COUNCIL ASSESSMENT REPORT

Panel Reference	PPSSCC-339
DA Number	DA 1110/2022/JP
LGA	The Hills Shire Council
Proposed Development	Amending Concept Development Application for a Residential Flat Building Development
Street Address	7-23 Cadman Crescent & 18-24 Hughes Avenue Castle Hill
Applicant	Castle Hill Panorama
Consultant/s	Mecone (Planner) InRoads: Group (Traffic Report) MHNDUnion (Architects) Neuron (Engineering Statement) RICQS (Quantity Surveyors) SurvPlan (Building Survey) TurfDesign Studio (Landscape Architects)
Date of DA lodgement	25 January 2022
Number of Submissions	Nil
Recommendation	Refusal
Regional Development Criteria (Part 2.4 and Schedule 6 of the SEPP (Planning Systems) 2021)	CIV exceeding \$30 million (\$85,490,156 excluding GST) and the development is the subject of a concept development application under Part 4 of the Environmental Planning and Assessment Act, 1979
List of all relevant s4.15(1)(a) matters	<ul style="list-style-type: none"> • State Environmental Planning Policy (Planning Systems) 2021 • State Environmental Planning Policy (Transport and Infrastructure) 2021 • State Environmental Planning Policy (Resilience and Hazards) 2021 • State Environmenta

Figure 1: Applicant's submitted Apartment Mix table in Drawing Number MP 4006 Revision A dated 15/12/2021

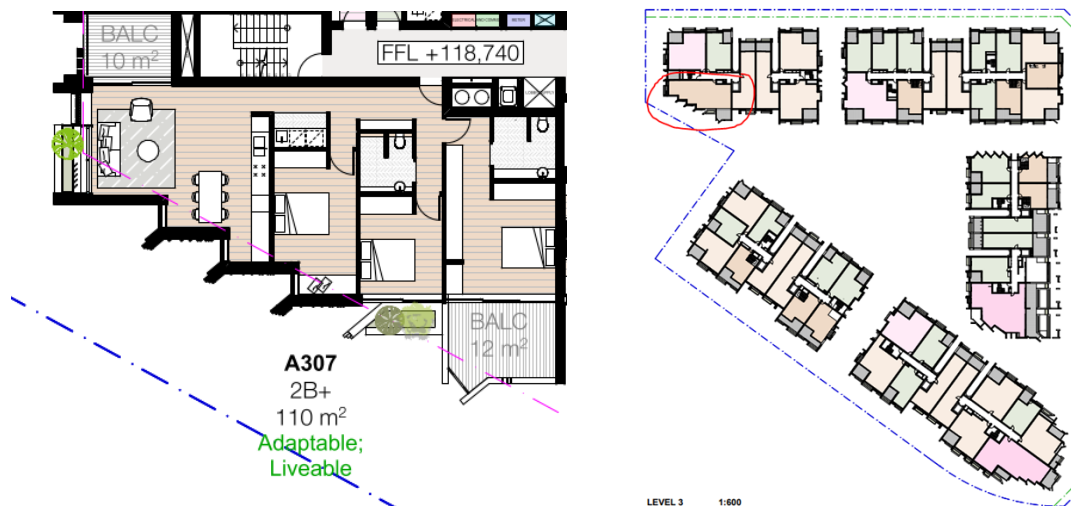
The submitted Statement of Environmental Effects and Drawing Number MP 4006 dated 15/12/2021 Revision A diagram indicates 55 out of **138** x 2 bedroom units (39.85%) comprise a minimum internal floor area of 110m². This already does not meet the minimum 40% percentage provisions for larger 2 bedroom units in accordance with Clause 9.7(2)(c). Further, the Apartment Mix table also incorrectly includes Units A307, A407, A507 and B512 as larger 2 bedroom units despite the plans indicating these are 3 bedroom units. Refer figures below:

In accordance with the submitted plans, the unit mix proposed is 64 x 1 bedroom units, **134** x 2 bedroom units and 57 x 3 bedroom units.

Figure 5: Proposed Building Lengths, Separation and Setbacks

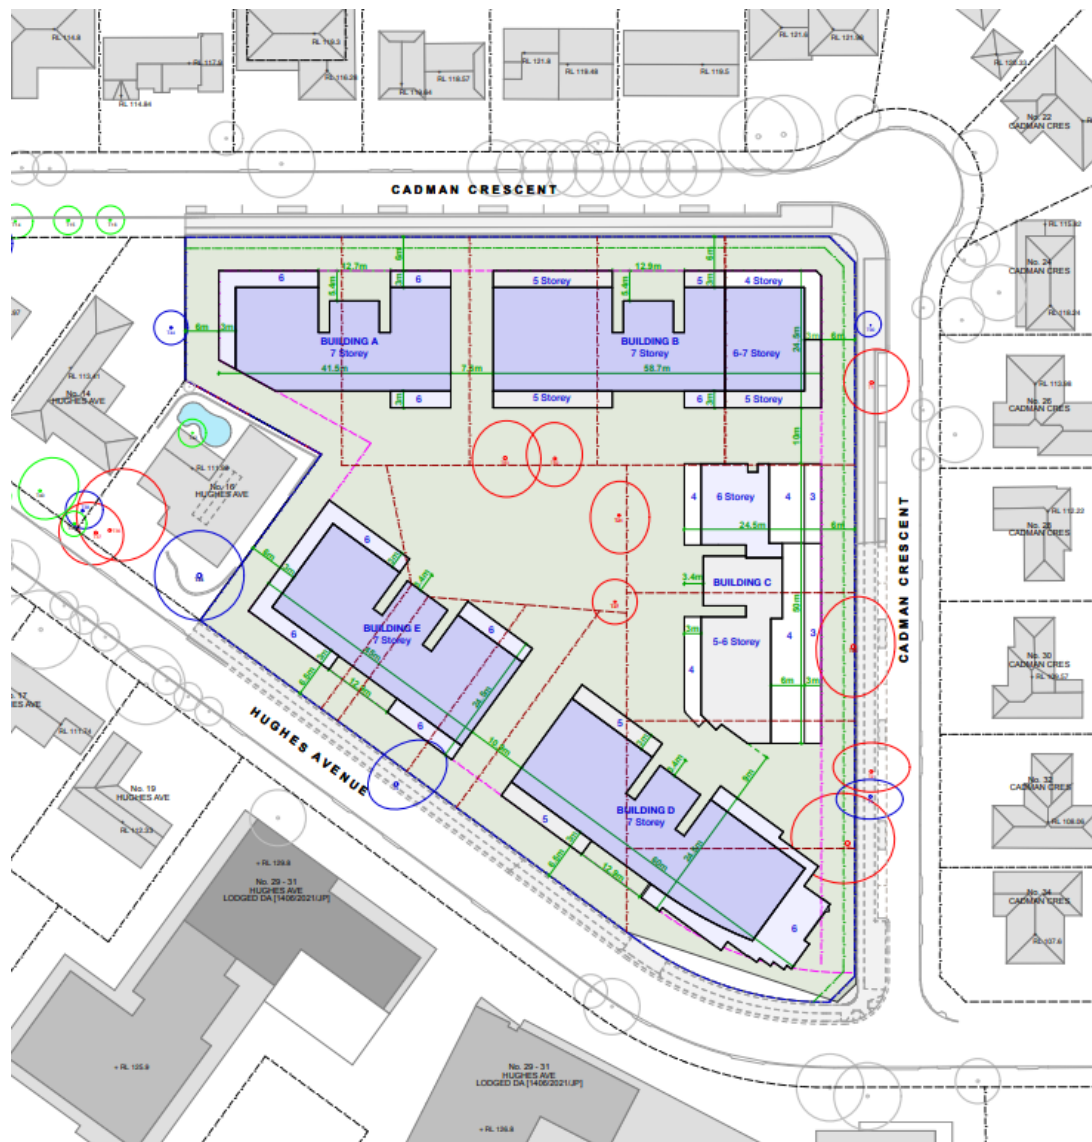
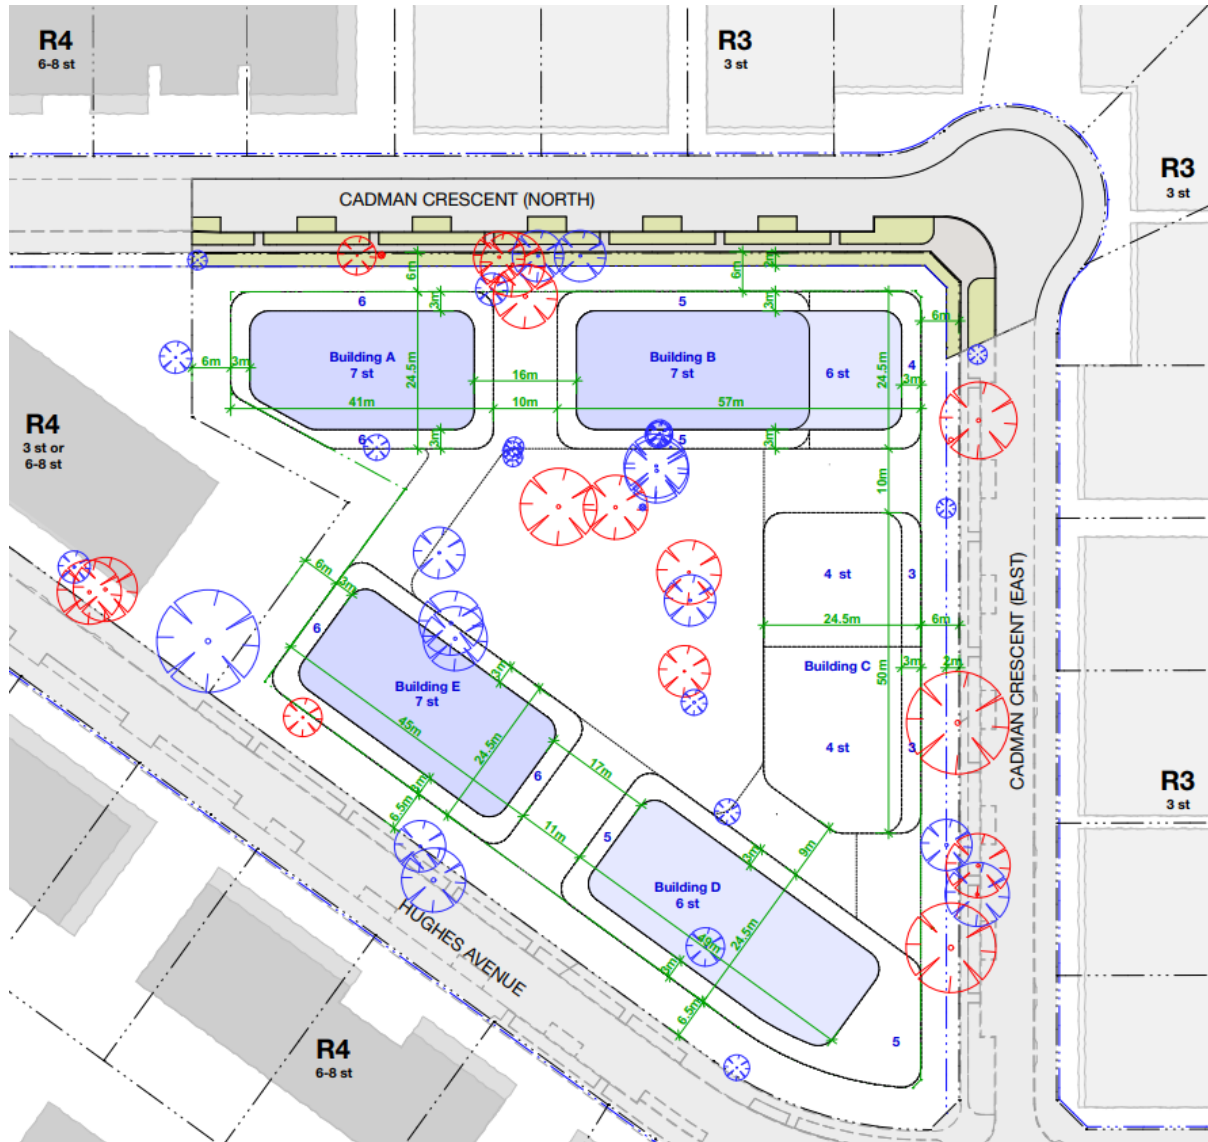
The approved concept application was supported with a variation to the front and upper floor of the building envelopes for blocks A, B and C which encroach within the Cadman Crescent East and North front setback by 1.5m and 1m respectively resulting in a front setback of 6m and upper floor setback of 3m. Refer to Figure 6 below.

The minor reduction to the 7.5m street setback control on Cadman Crescent was supported, due to the lower adjacent heights and density, the irregular shape of the site, and the negligible impact on the internal communal open space. It was assessed that the reduced front setbacks were commensurate with the interface between the differing R4/R3 residential density zones given the maximum three storey height of Building C. It was considered that this building envelope would provide for future built form that has the potential to provide strong definition to the public domain and create a consistent streetscape.

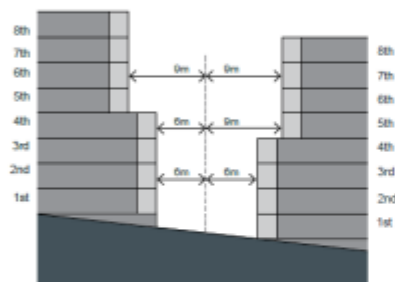
- It remains unclear to the Panel whether the proposal is relying on a change to the existing kerb alignment in the street carriageways. The applicant must resolve this separately with Council prior to further design development.
- Improved compliance with statutory controls for maximum built form length and separation between blocks should be reviewed.

Massing provided by applicant

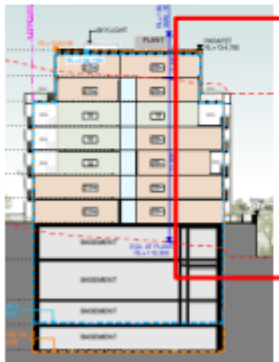
- The development appears large, bulky and homogenous, particularly when compared to previous submissions. The lack of the required 4m setback at the 4th storey contributes to this.
- The proposed building lengths are not in compliance with the intent of the DCP control.

- The pervasive non-compliance with statutory controls results in a perception of overwhelming density, bulk and scale the development presented to the street and the central open space.
- The street interface appears to have walls in excess of 2m in height of substantial length. This is not considered to offer a fine grained and active street frontage.
- The building form, layout and character is generally typical of development across most parts of metropolitan Sydney, and the Panel requests further description identifying how the design has been informed by the locality, climate and context of the Hills district.

Apartment Mix and Building Design

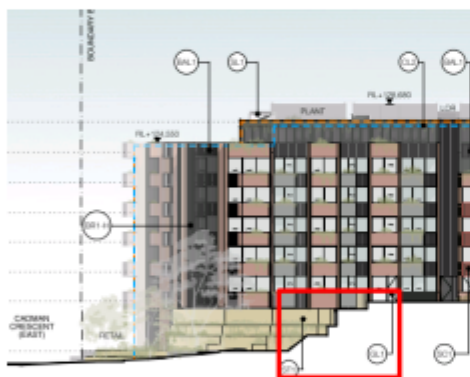
- The Panel does not support apartments that are located below the adjacent public domain be it the street frontage or internal courtyard area. This is for reasons of visual privacy, natural ventilation and solar access
- All BCA fire egress requirements are to be resolved and clearly documented to the satisfaction of council prior to the final DA submission.
- All apartments are to be accessible from a lobby that is directly visible and accessible from the street frontage for that development block.

Figure 3: Articulation - p.14

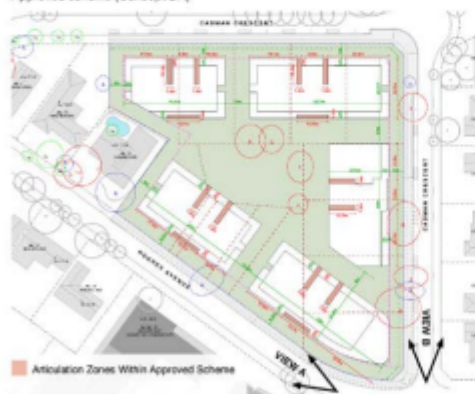
Increased Setback & Articulation

Figure 5: Building Height – p.25

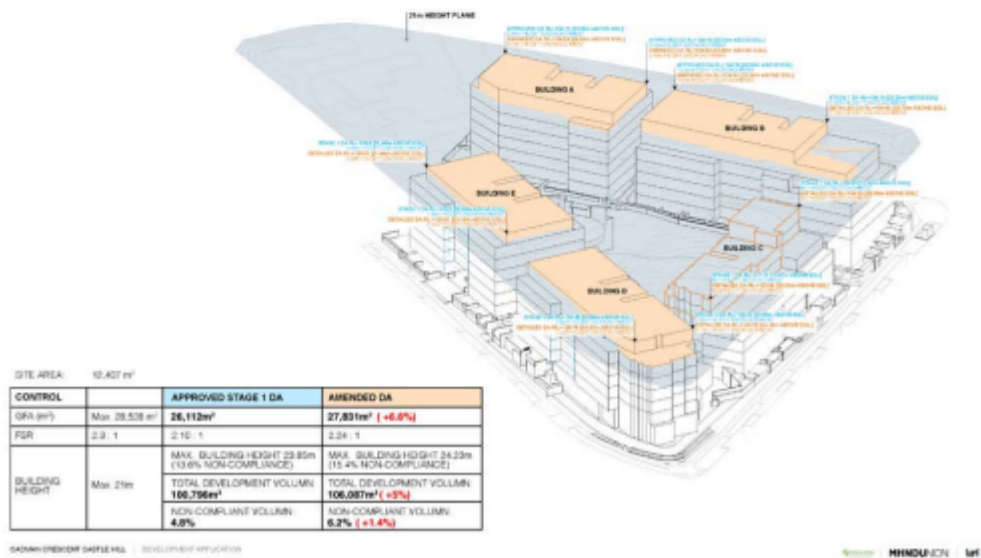
Building Height - Quantitative Analysis

Figure 6: Diversity - p.49

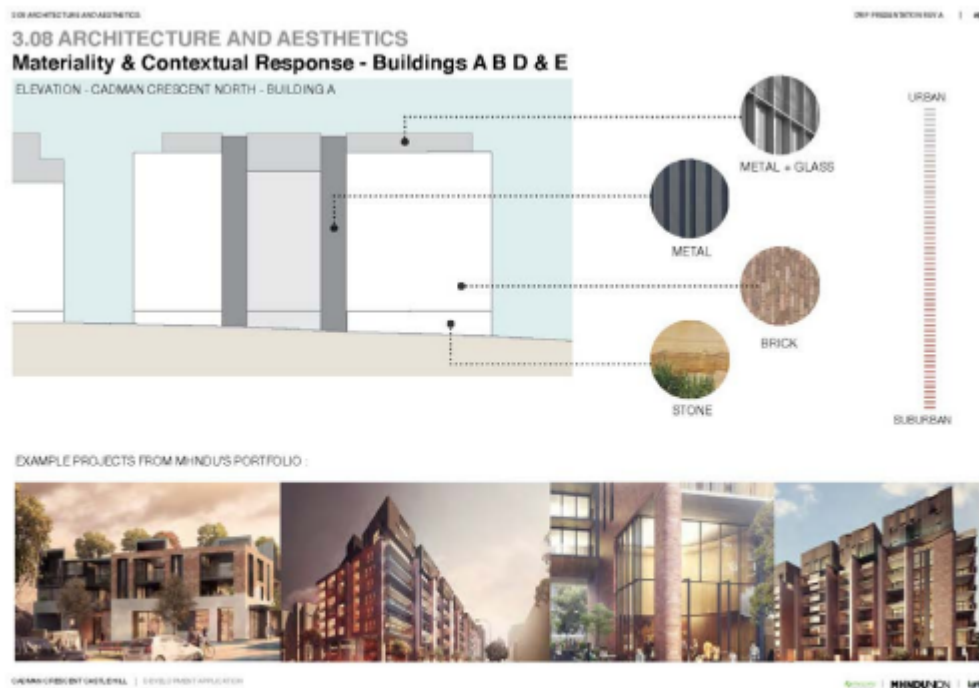
The projection of generous overhanging planting on private balconies and roofs is effective in reducing the perception of bulk and scale of the built form but will also be difficult to manage and maintain by occupants.

The prominence of the two lift cores on the roof of Building C contradicts the urban design strategy to underscore the impact of the two new levels from the public domain. While being important architectural elements, the lift overruns increase the bulk and scale of Building C when viewed from the public domain. The relocation of the lifts in the recesses closer to the central courtyard (similar to Buildings A and B) or use of a transit lobby would be more compatible with the broader design intent.

Figure 7: Material Palette - p.48

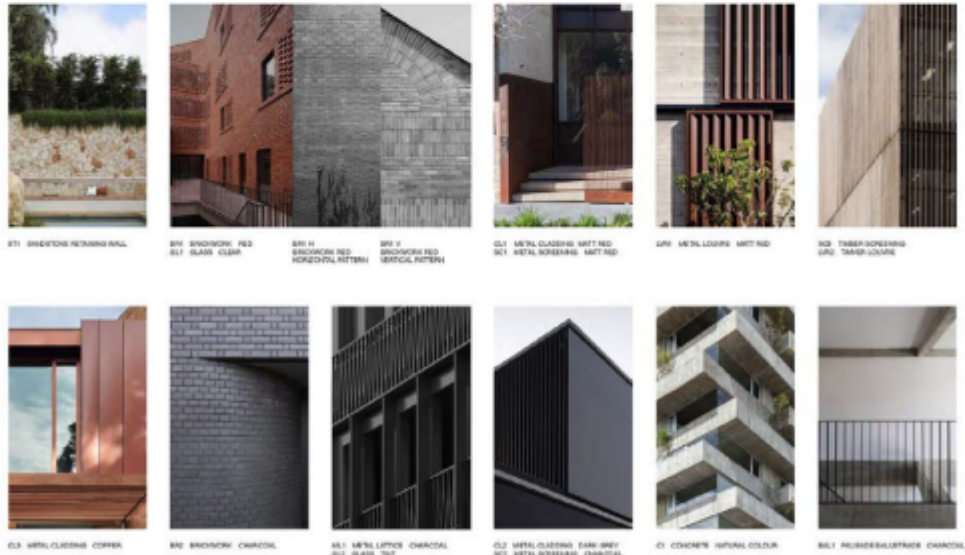
The comments of the Design Review Panel, in its review of 23 March 2022, refer to the aesthetic as 'imposing' and 'architecturally homogenous' which is at odds with the rich external expression evident in street and courtyard illustrations and elevations. The Panel supports the material palette but does not acknowledge the diversity of expression which is well handled and an effective and distinguishing element of the building design.
